Reference: N318/2024/RTC/01

**RE: Unit 1 & 2 - 77 Bassett Street, Mona Vale (DA2023/1841)**

**Development application for a proposed change of use to hand and power tools store - Response to Council on traffic and parking matters**

DRAWING TITLE:  
 PARKING SITE PLAN

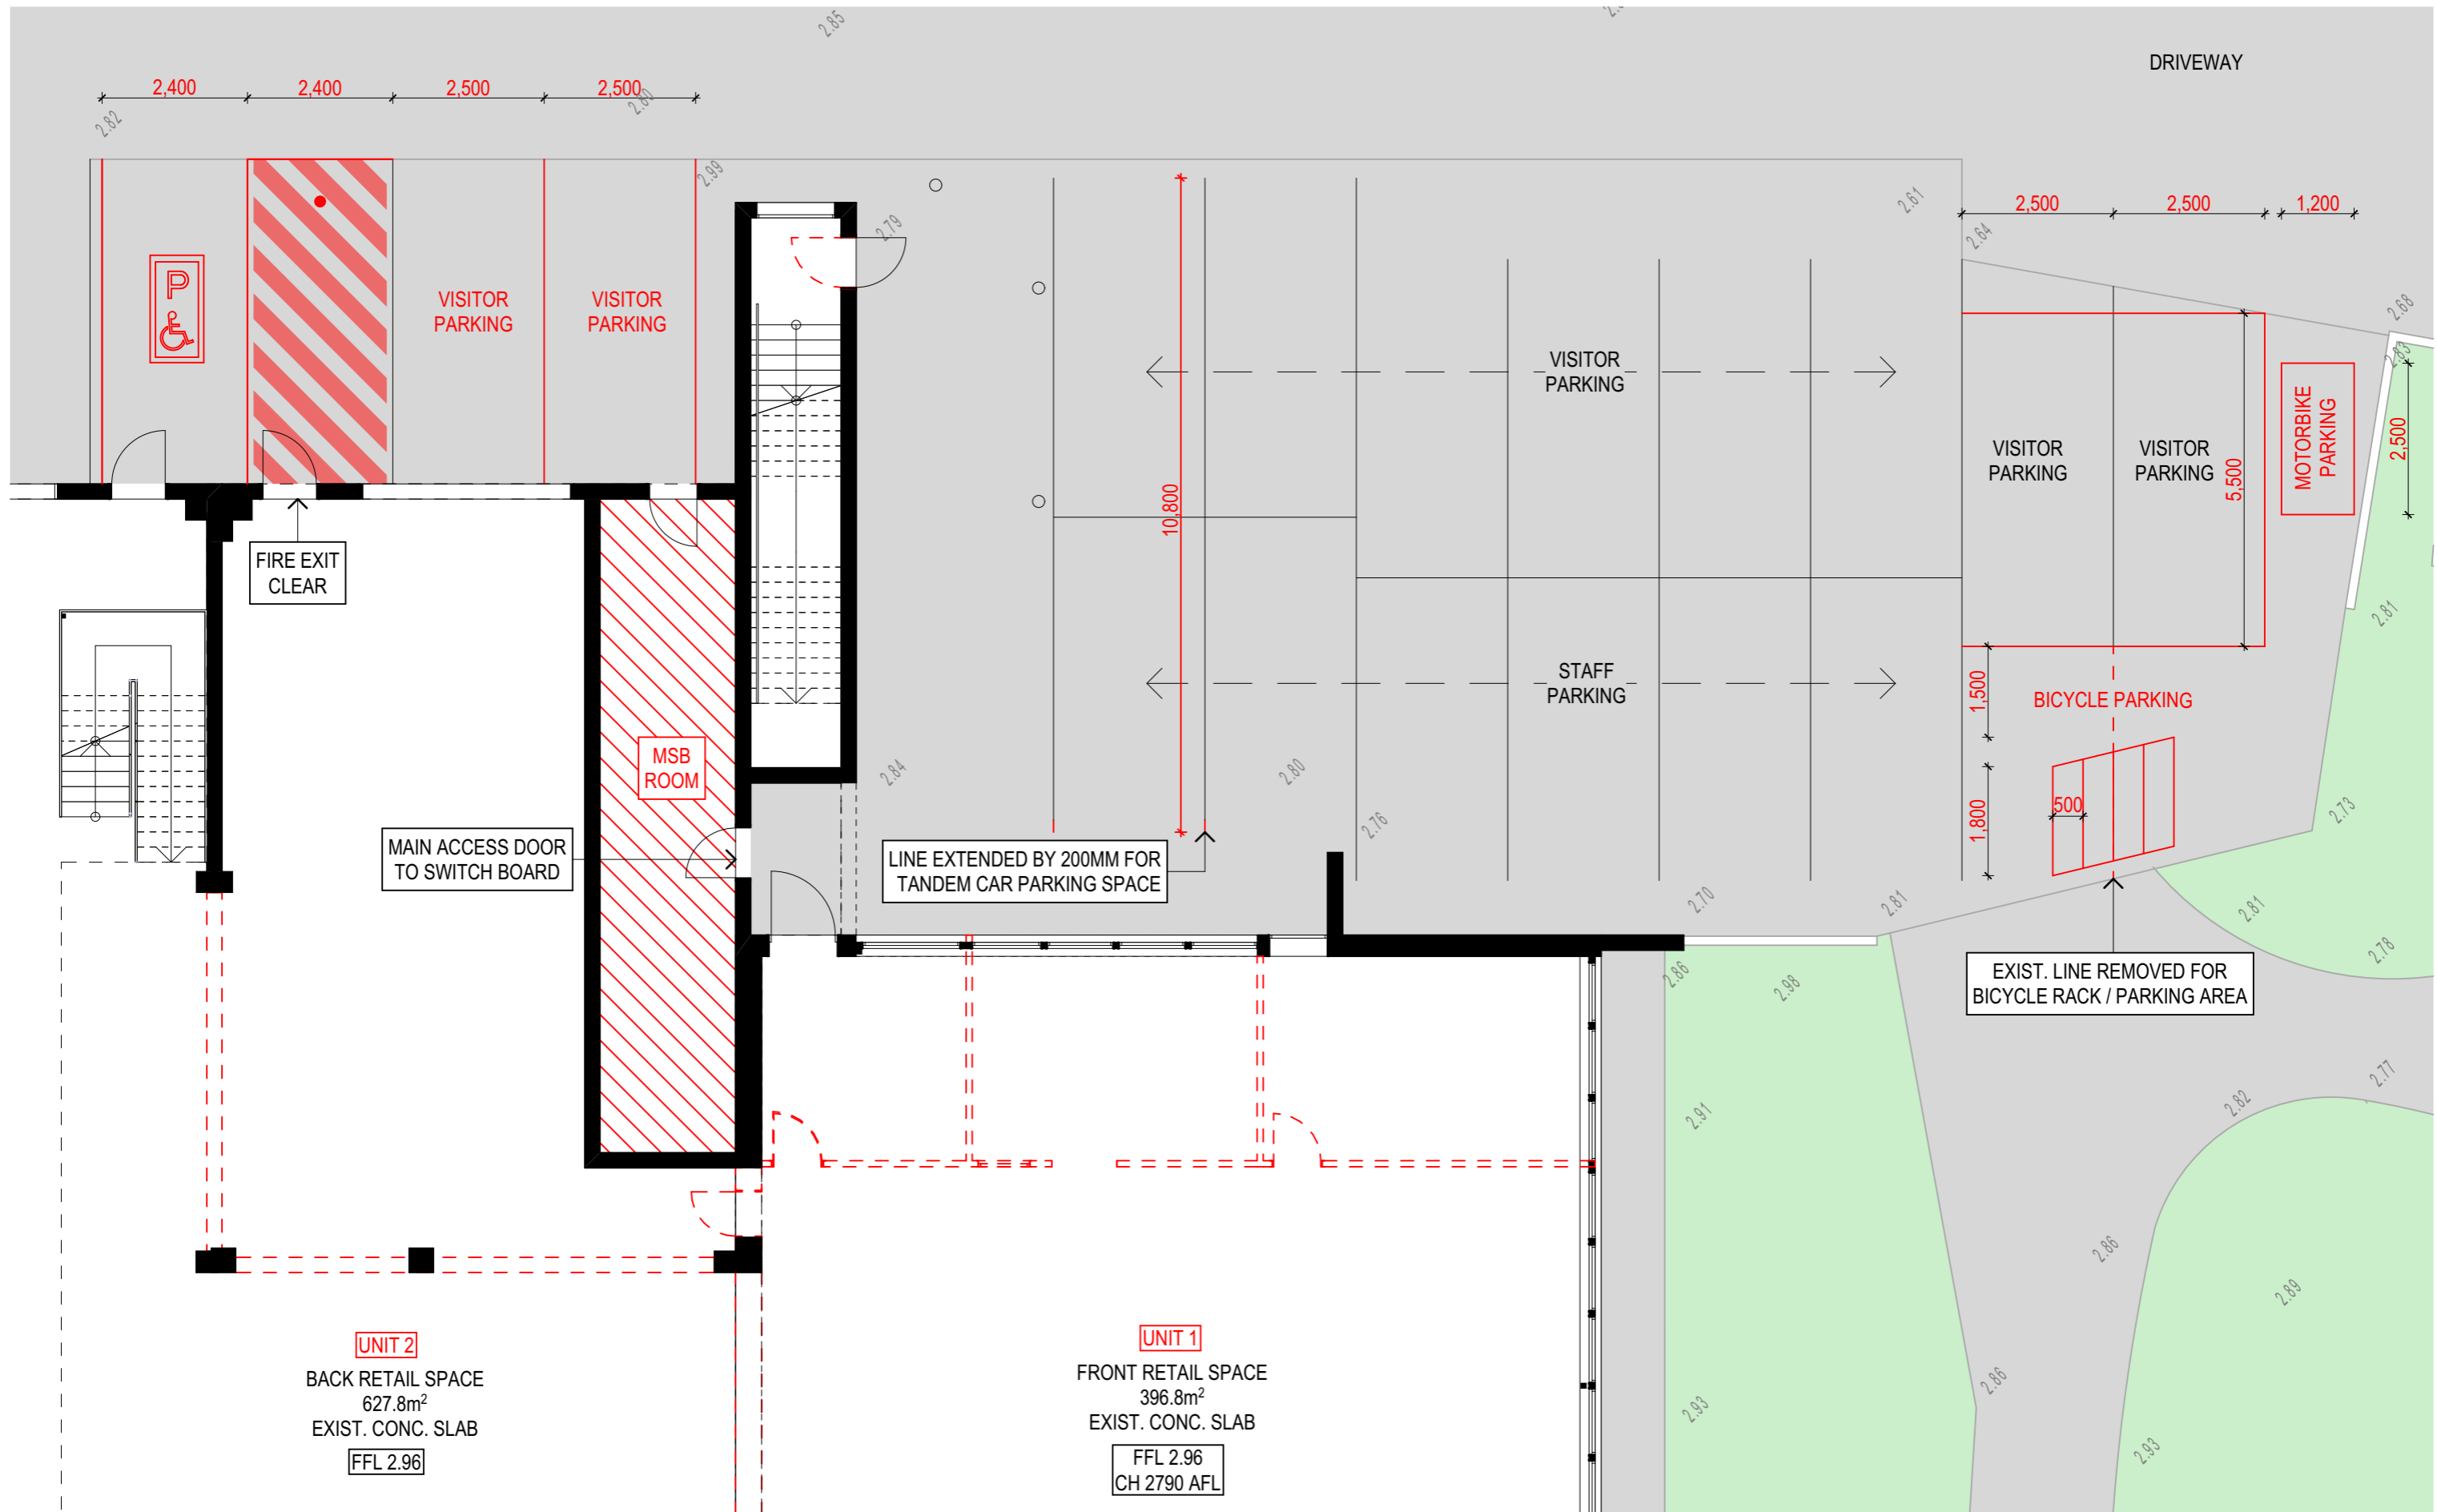
- It is noted that the traffic report shows 2 car parking spaces along the western boundary of the bigger site (figure 4.1 on page 9). These spaces are not shown on the architectural plans. The two documents should be consistent with the location and dimensions of all parking spaces shown on the plans.

- The traffic report mentions that a maximum of 5 staff will be present at any given time however 7 staff parking spaces are proposed. This is both unnecessary and reduces the level of parking available for customers. It is suspected that the reason that 7 spaces have been allocated for staff use is there are seven spaces buried in tandem parking arrangements. Such spaces would therefore be inappropriate for use by customers however simply reallocating those spaces for unnecessary staff parking is not acceptable. If anything, the quantum of staff parking could be reduced below 5 which would encourage staff to use public transport, walk or cycle or motorcycle to work and increase the level of customer parking .

- No motorcycle or bicycle parking has been provided. The Pittwater DCP requires at least one motorcycle space and 4 bicycle parking spaces. These could be sited at the front end of parking spaces 77 & 78 which are of extended length without impacting on the ability of vehicles to park in or access these spaces. The provision of such spaces would encourage travel by alternate means, particularly by staff.

- The revised scheme includes the following parking provision:

Parking Type	Visitor	Staff
Car	11	6
Disabled Parking	1	0
Motorcycle	1	0
Bicycle	0	4

- Based on the above the revised scheme provides a total of 18 car parking spaces including 1 disabled parking space in compliance with clause c5.5 of the Pittwater DCP.

- The revised development also satisfies the motorcycle and bicycle parking requirements relevant to the proposed development.
- The revised scheme includes 6 staff parking spaces, whilst the staff parking along the western boundary of the bigger site has been converted for pallet parking or storage purposes. It is noted that the proposed facility will be managed by 5 staff members at any given time. The TIA report assumes that each staff member will drive to the site and therefore 5 parking spaces should be allocated for staff usage only. As such, the proposed development scheme provides only 1 additional staff parking.

DRAWING TITLE:  
 PARKING PLAN

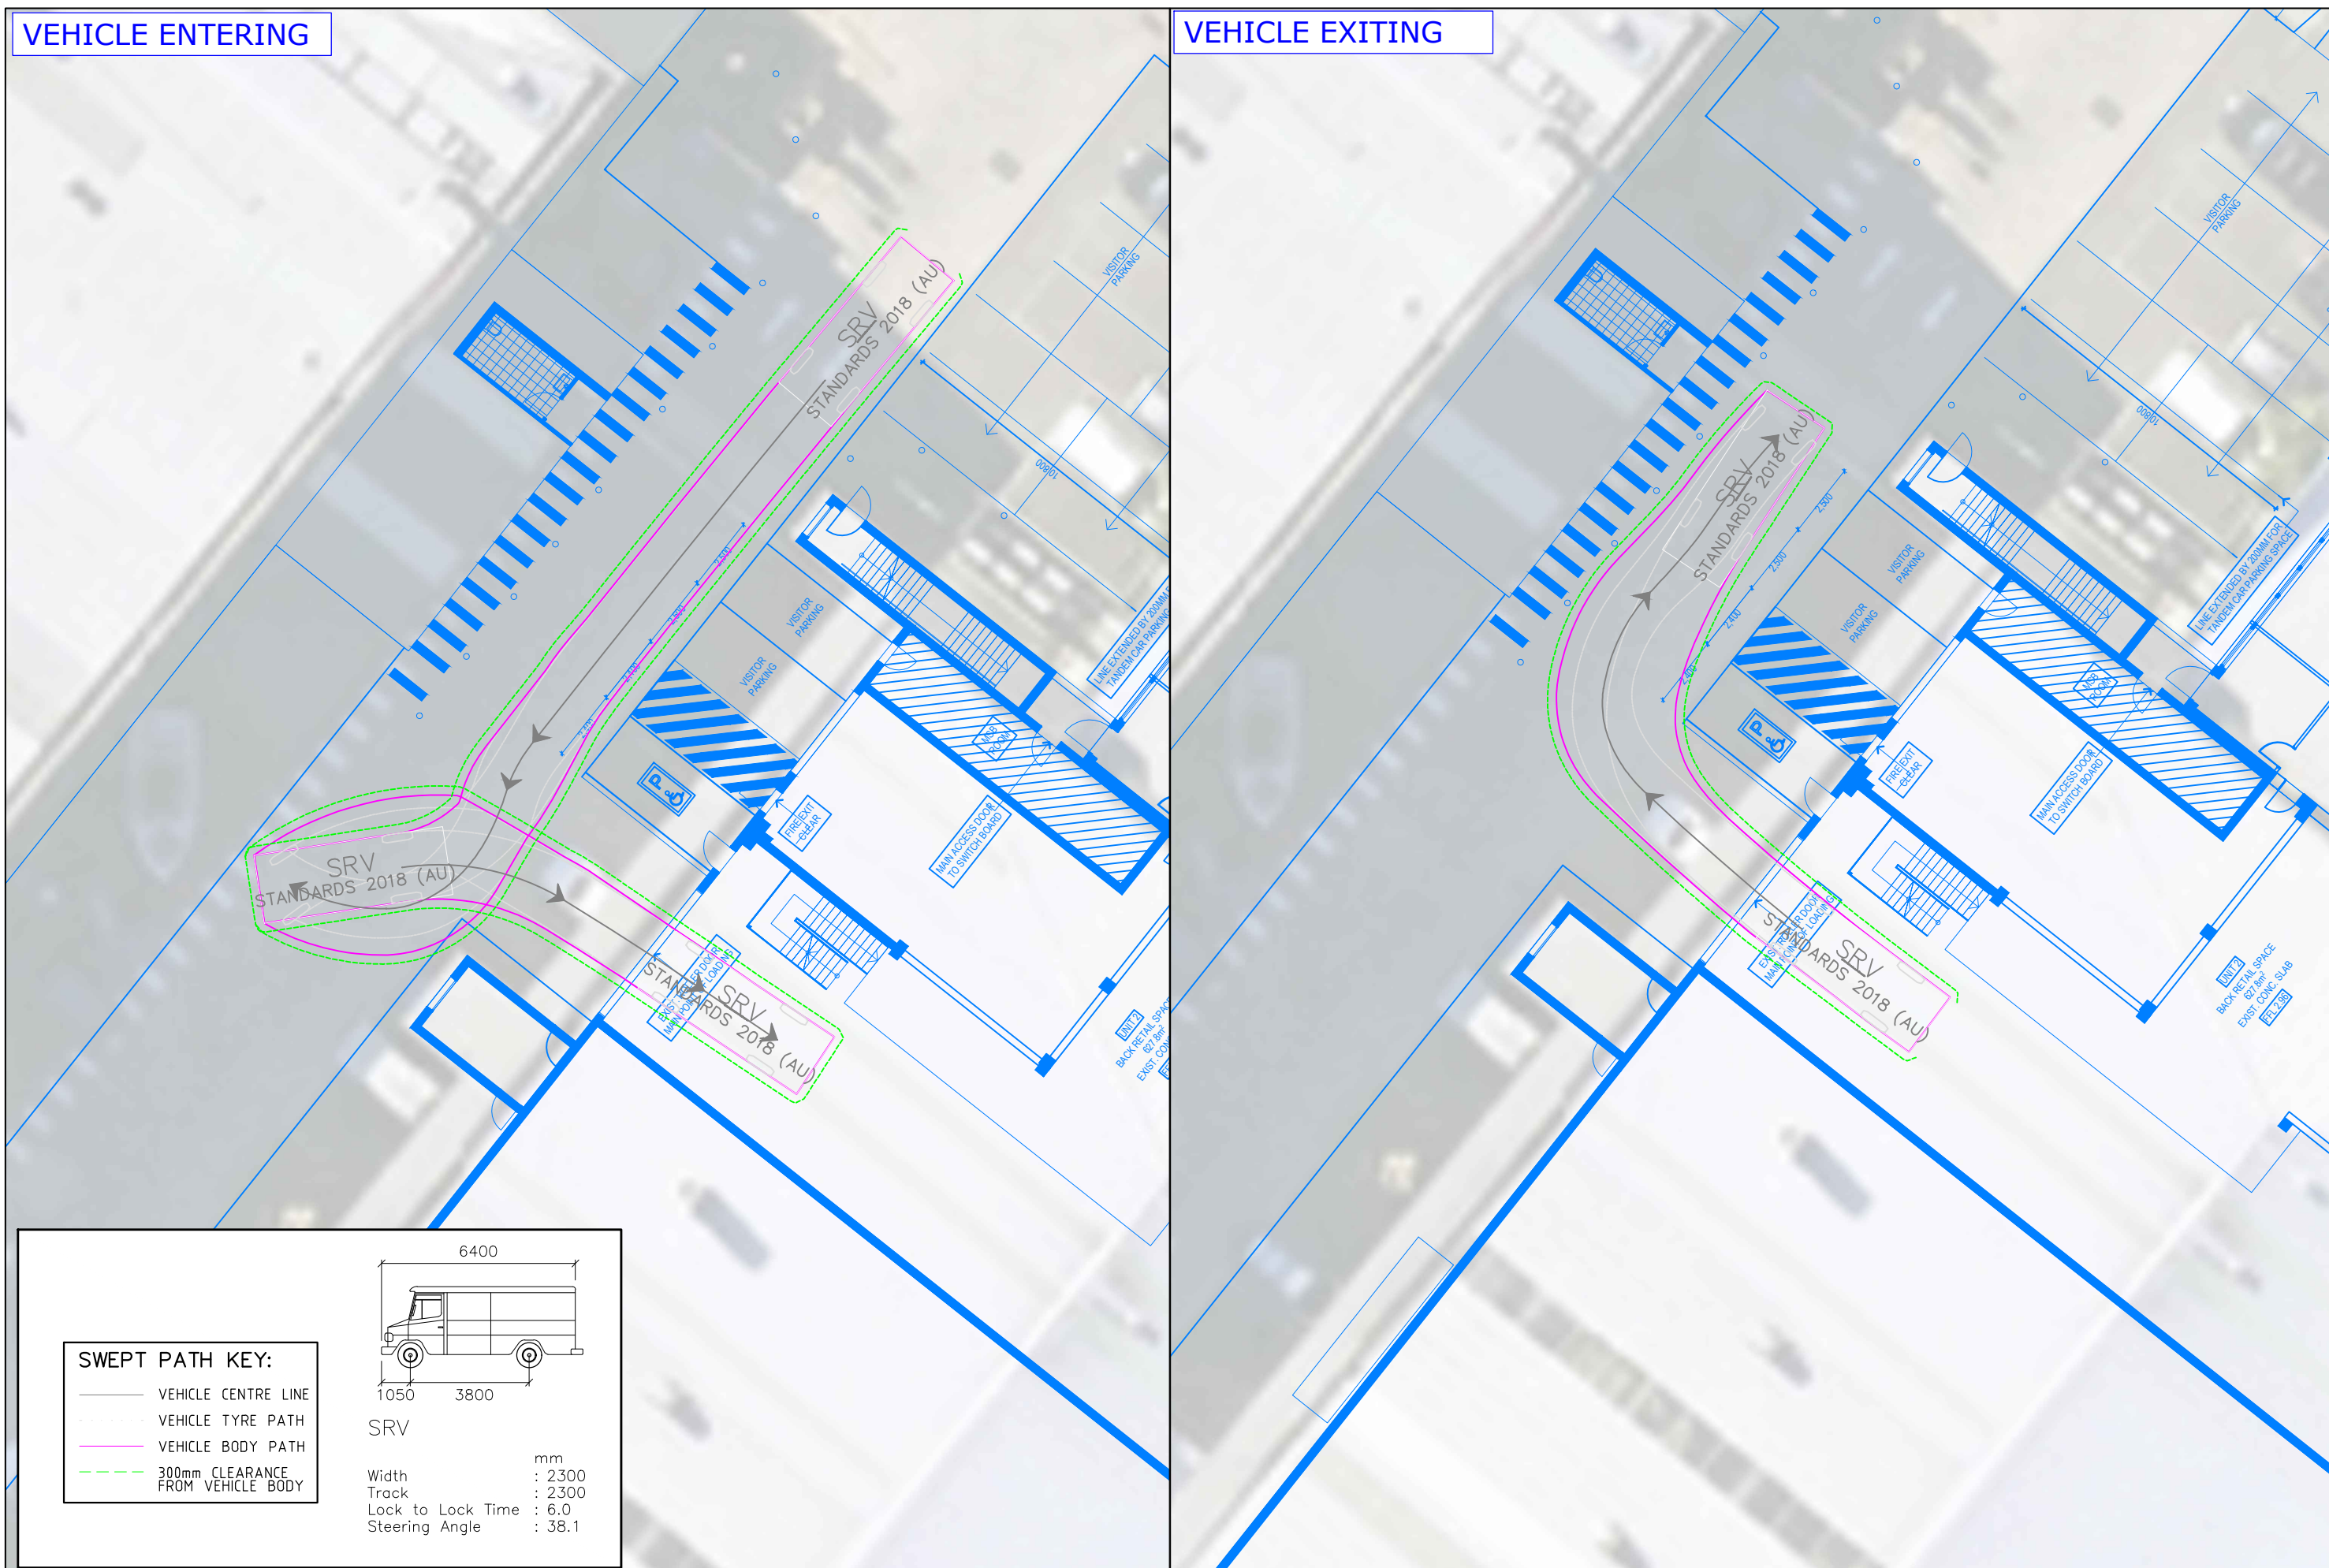
providing parking for no less than 23 cars. The bulk of this parking should be allocated for customer parking with it noted that clause c5.5 of the Pittwater DCP requires that carparking be provided for people with disabilities so at least one parking spaces should be designed and located appropriately for disabled use. The developer must review their proposal and seek additional parking for customers, to support their development. The additional parking should be buried in a tandem arrangement.
